ADDENDUM NUMBER TWO

MOCCASIN BEND O&C BUILDING RE-ROOFING PROJECT CONTRACT NO. W-16-015-201

CITY OF CHATTANOOGA, TENNESSEE

ROOF PLAN - OPERATIONS BLDG.

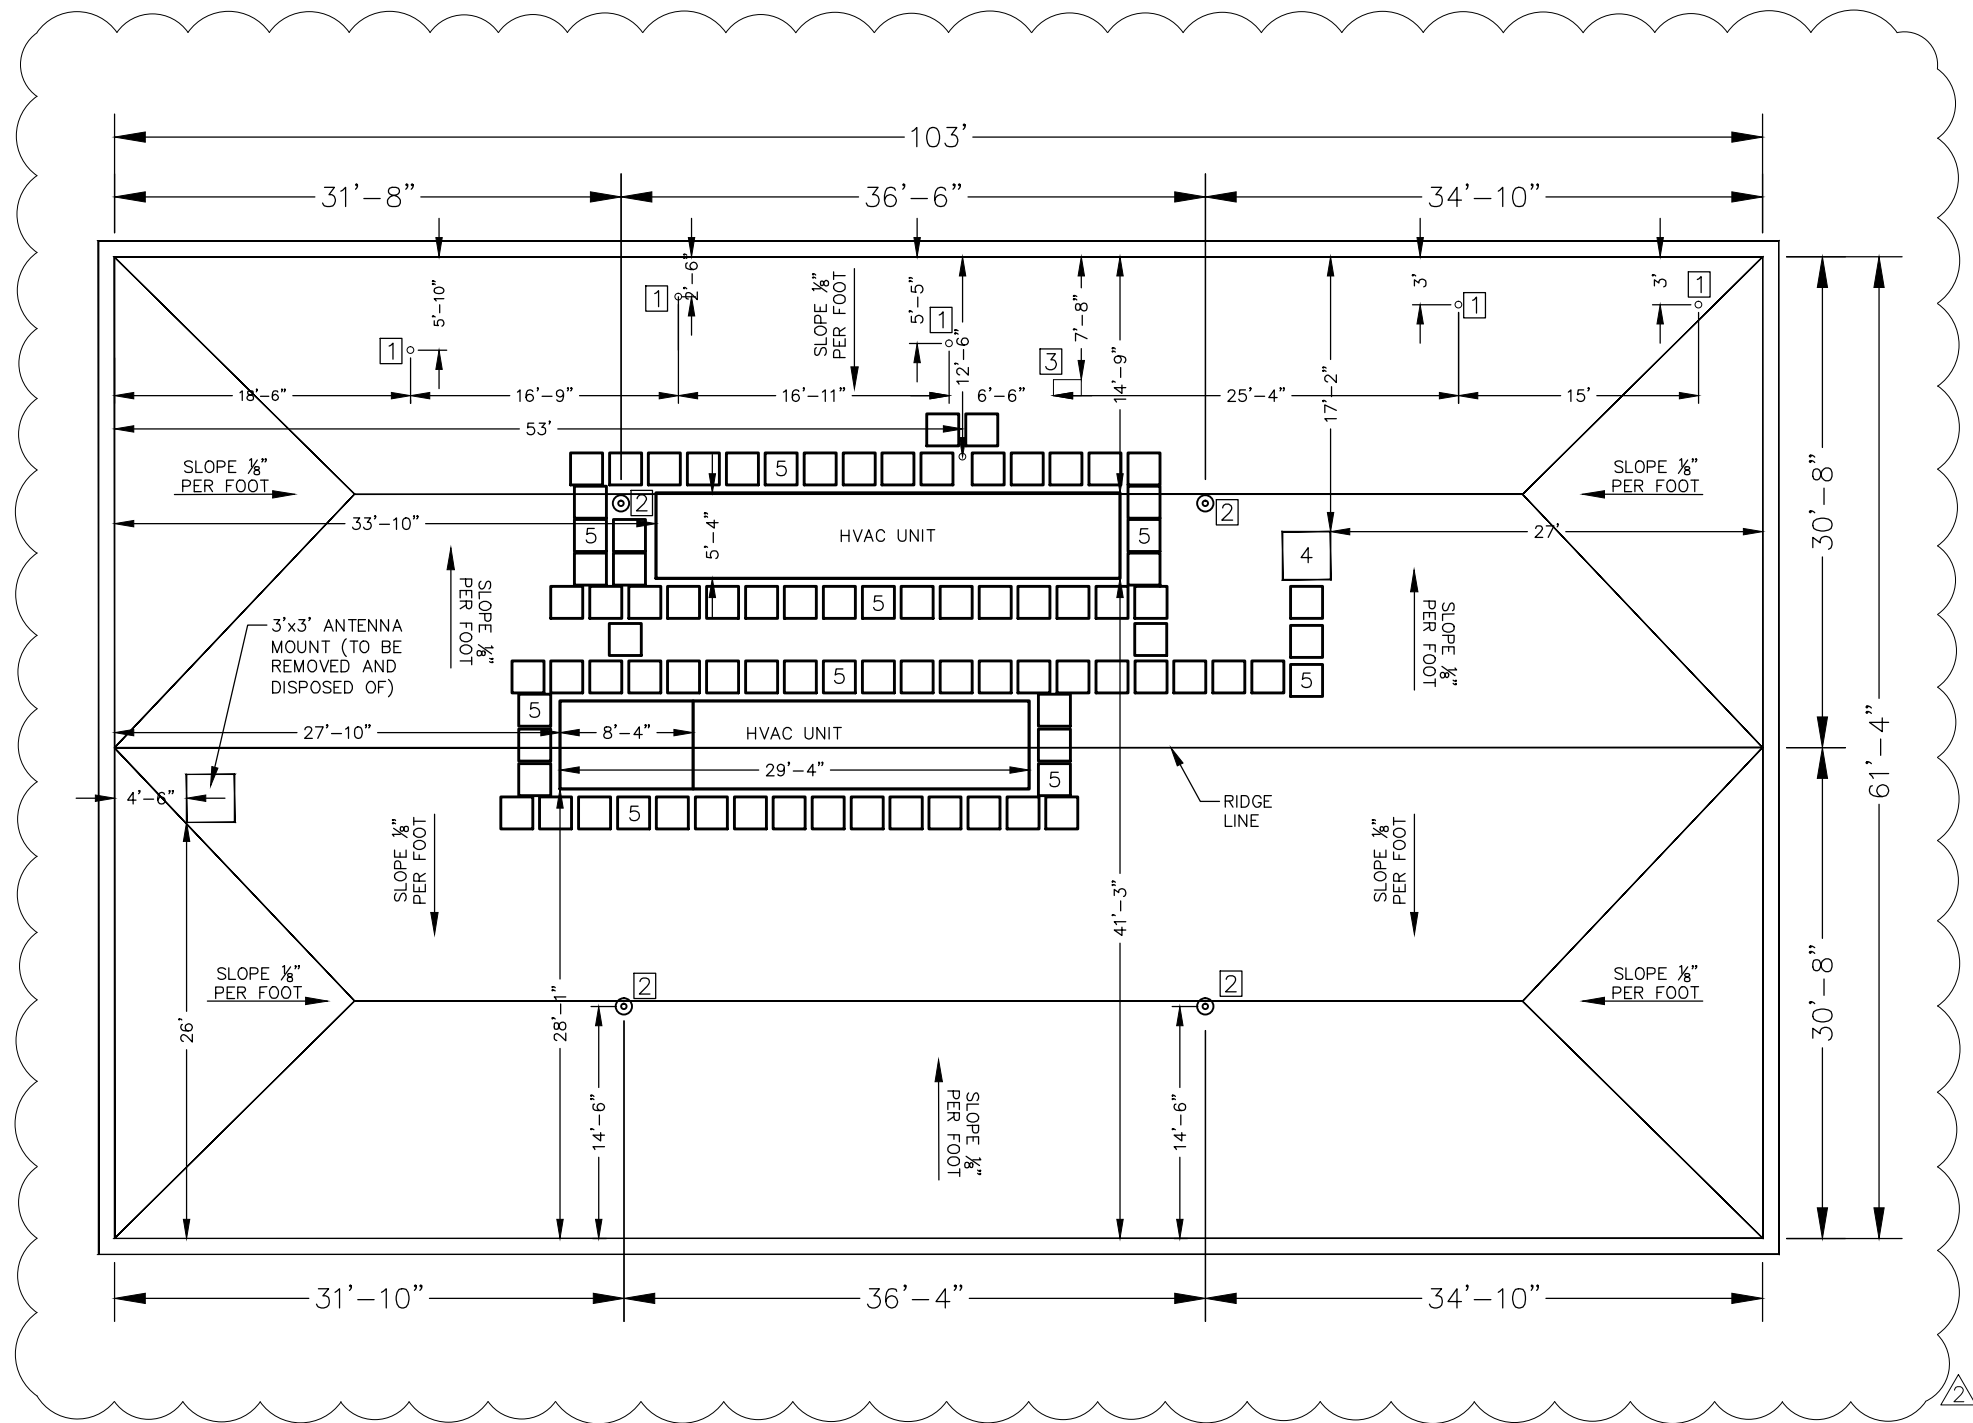
Revised Drawings, Added dimensions to sheet 2 of 5.
